Accessibility Survey

City of Downey Earnshaw Avenue - Golden Street To Century Boulevard

Date of Inspection 11/28/2016

Disability Access Consultants

Change In Level North Of Century Boulevard @ 33.907105916192, - 118.149259239435

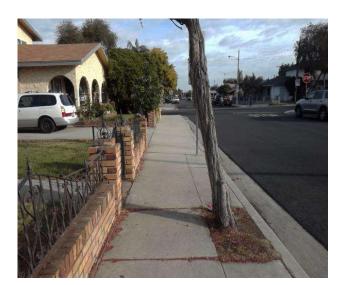
Sidewalks , Change in Level : Change in Level Non Beveled

There is a change in elevation greater than recommended value.

On-Site Finding 0.50 inches

Ensure that the change in elevation is within the recommended value.

Recommendation Up to 0.25 inches

Sidewalk South Of Golden Street @ 33.908821094255, -118.147922158241

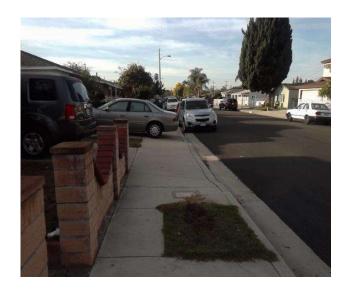
Sidewalk does not have enough width.

On-Site Finding 28.00 inches for 3.00 feet

Widen the sidewalk to the recommended value.

Recommendation At least 48.00 inches

Tree South Of Prichard Street @ 33.906257775156, -118.149660229683

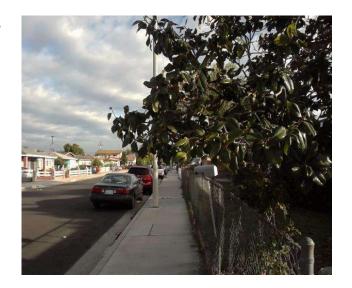
Overhead obstruction height is not compliant.

On-Site Finding 66.00 inches

Provide a compliant vertical clearance height.

Recommendation At least 80.00 inches
